Project	IEEE 802.16 Broadband Wireless Access Working Group < http://ieee802.org/16 >
Title	Fix broken message flow in HO decision & initiation
Date Submitted	2005-07-14
Source(s)	David Xiang, Phillip Barber, Jim Carlo, Duke Dang, Lucy Chen, John Lee mailto: dxiang@futurewei.com HUAWEI
Re:	Call for contribution and comments.
Abstract	Fix broken message flow in HO decision & initiation
Purpose	Adoption
Notice	This document has been prepared to assist IEEE 802.16. It is offered as a basis for discussion and is not binding on the contributing individual(s) or organization(s). The material in this document is subject to change in form and content after further study. The contributor(s) reserve(s) the right to add, amend or withdraw material contained herein.
Release	The contributor grants a free, irrevocable license to the IEEE to incorporate material contained in this contribution, and any modifications thereof, in the creation of an IEEE Standards publication; to copyright in the IEEE's name any IEEE Standards publication even though it may include portions of this contribution; and at the IEEE's sole discretion to permit others to reproduce in whole or in part the resulting IEEE Sta

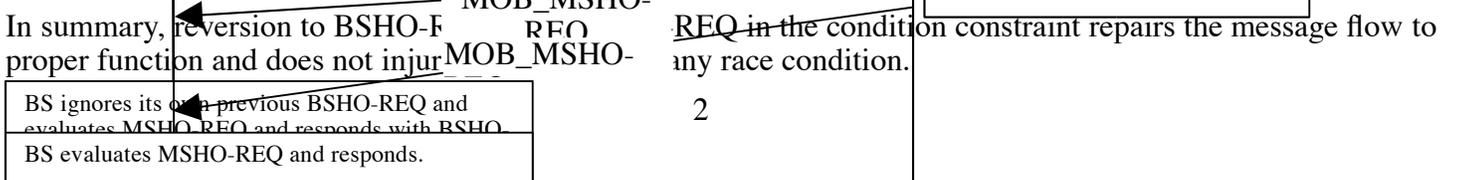
A change to the D8 document on handover race condition mitigation has broken the normal messaging sequencing. More specifically, a change to 6.3.21.2.2 HO decision & initiation, page 178, paragraph 2 was changed to:

If an MS that transmitted a MOB_MSHO-REQ message detects an incoming MOB_BSHO-REQ message, it may respond with a MOB_MSHO-REQ or a MOB_HO-IND message and ignore its own previous request. A BS that transmitted a MOB_BSHO-REQ message and detects an incoming MOB_MSHO-REQ message from the same MS shall ignore its **MOB_MSHO-REQ [emphasis added]**. A BS that transmitted a MOB_BSHO-REQ message and detects an incoming MOB_HO-IND message from the same MS shall ignore its own previous request.

The change of the message (in bold in the text) from MOB_BSHO-REQ to MOB_MSHO-REQ has disastrous results as can be seen in the following diagram.

Revert language in 6.3.21.2.2 HO decision & initiation, page 178, paragraph 2 back to original text.

[In 6.3.21.2.2 HO decision & initiation, page 178, lines 12-18, modify paragraph as:]

If an MS that transmitted a MOB_MSHO-REQ message detects an incoming MOB_BSHO-REQ message, it may respond with a MOB_MSHO-REQ or a MOB_HO-IND message and ignore its own previous request. A BS that transmitted a MOB_BSHO-REQ message and detects an incoming MOB_MSHO-REQ message from the same MS shall ignore its ~~MOB_MSHO-REQ MOB_BSHO-REQ~~. A BS that transmitted a MOB_BSHO-REQ message and detects an incoming MOB_HO-IND message from the same MS shall ignore its own previous request.

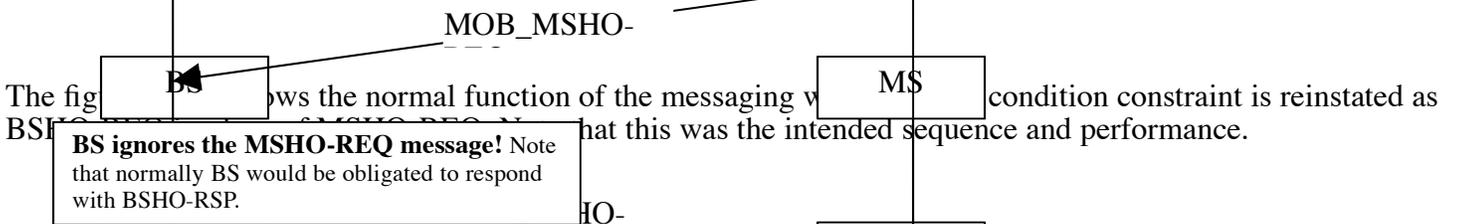
Changing the instance back to BSHO-REQ does not create a problem as the following diagrams demonstrate:

MS evaluates the BSHO-RSP and determines to:
Resequence the Target BS list and re-submit the modified list to the BS for consideration for handover as another MSHO-REQ, or;
Accept the BSHO-REQ and issue a HO-IND response with HO_IND_type=0b00, or;
Reject the BSHO-REQ and issue a HO-IND respond with HO_IND_type=0b10, or;
Ignore the BSHO-RSP message and issue no MS message
